MEMORANDUM

From:	Tina Cuss Ecology Officer		
Service	WBC Ecology	App No:	252892
Address:	59 Nine Mile Ride, Finchampstead, Wokingham, RG40 4ND.		
Proposal:	Application for submission of details to comply with the following condition of planning consent 233133 dated 26/02/2024. Condition 15 relates to external lighting.		
Type of Development:			
Site Visit Made:	No

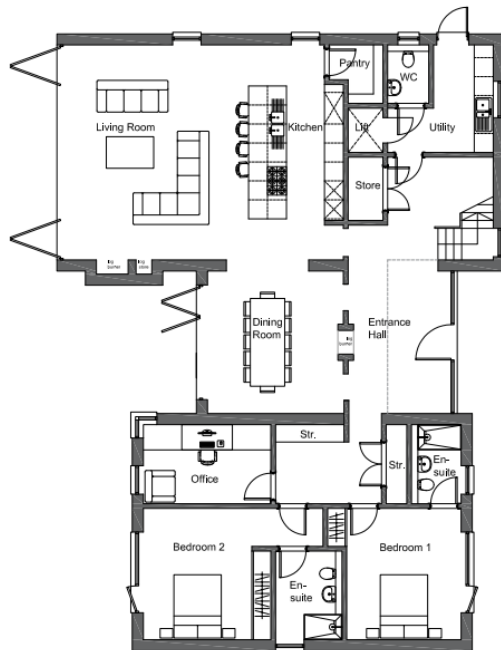
No contours are shown for 34 and 35B in Dwg Rev C or D, and no amendments have been made to 34-37B to protect and maintain a dark corridor on the eastern ecological corridor. According to the schedule and letter I am concerned that the owner appears to propose to light 34-37C all night. I cannot support approval of condition 15 unless the lighting round the gates (particularly the east) which would cause disturbance and light pollution to the grassland and hedgerow wildlife corridor. If the applicant can demonstrate it is necessary, 1 louvered wall light controlled by PIR on the western side of the access road may be justified. Currently the applicant has not addressed that 36 and 37B will be obscured when the gate is open, and the submissions do not clarify if the gate is remotely and/or electronically operated. The BEGA recessed wall lights proposed are available in 2700K and well as 3000K, the warmer light should therefore also be specified where possible.

If 31C and 35—37B and 25C are removed, 25C, 28 and 29C are lowered, and clarification regarding controls is provided, and the drawing proposals for continuous lighting from dusk till dawn is removed, I am likely to be able to support approval of the proposals for Unit 4. In order that there will not be detrimental impact to wildlife and the habitat corridor, the report and the drawing must also demonstrate how 34B will be controlled and provide the omitted contours, 208-01-NAD-CG must be amended to confirm light at the gate would be controlled by a PIR and not lit dusk till dawn.
